Peach Bottom Atomic Power Station, Unit 2
Facility Operating License No. DPR-44
NRC Docket No. 50-277

Subject: License Amendment Request 02-00304
Safety Limit Minimum Critical Power Ratio (SLM CPR) Change

LICENSE AMENDMENT REQUEST 02-00304

"Revision of SLMCPRs"

Figure 2 Reference Core Loading Pattern – Cycle 15

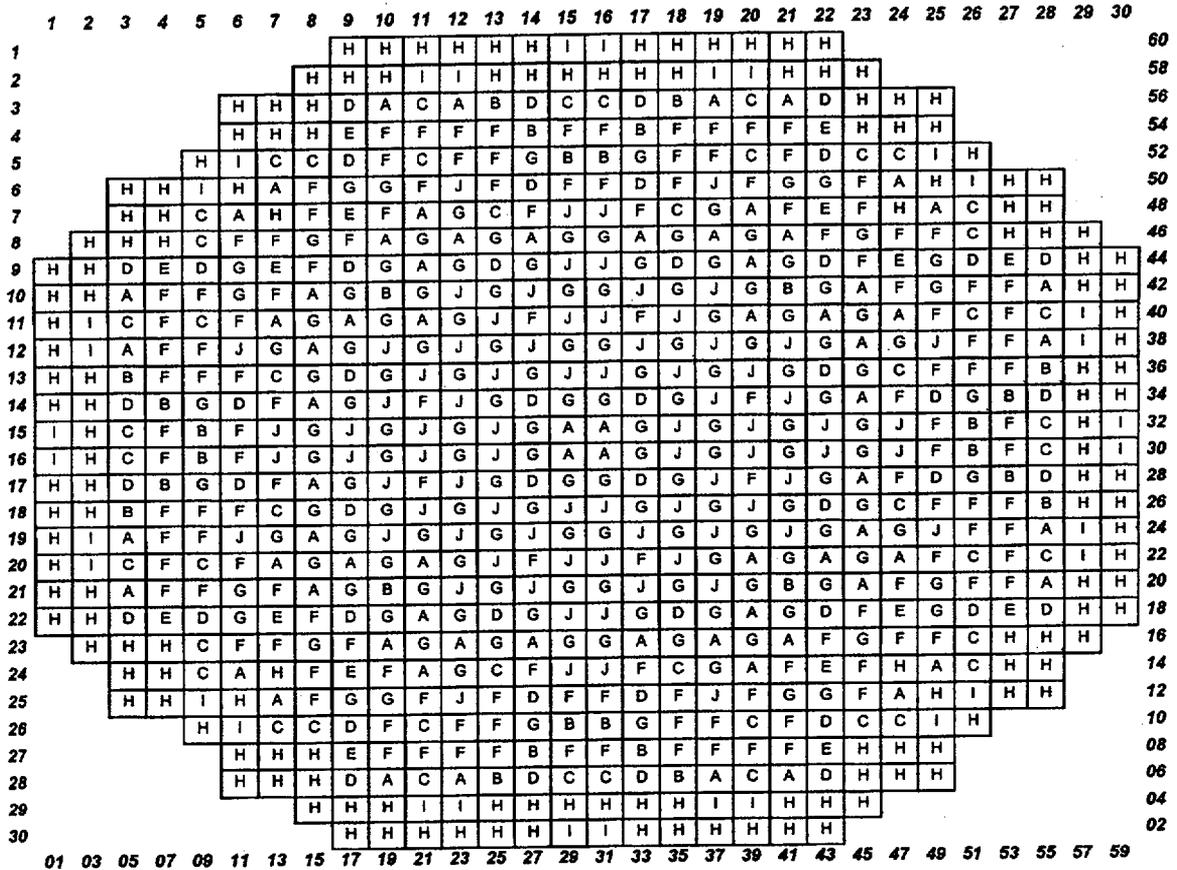
The core loading information for Peach Bottom Unit 2 Cycles 14 and 15 is provided in Figures 1 and 2, respectively. The impact of the fuel loading pattern differences on the calculated SLMCPR is correlated to the values of [[]]
